**STANDARD ROAD PLAN RD-21B**

REVISION NO. 5

REVISION DATE 04-19-05

FUSE PLATE ASSEMBLY  
(FOR BREAKAWAY SIGN POST)

DETAILS OF FUSE PLATE ASSEMBLY

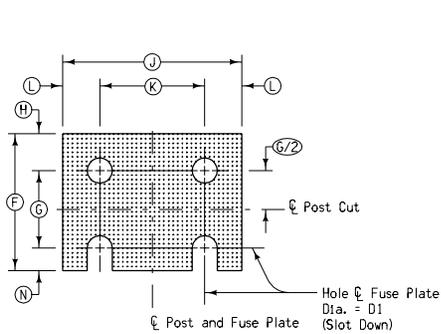
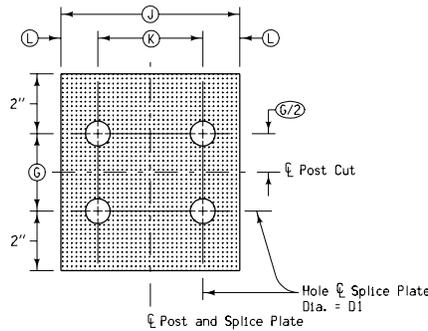
REVISION: Remove ref. to zinc rich paint; correct T4 in table for W8x18; remove notes covered in Spec. Book; change title.
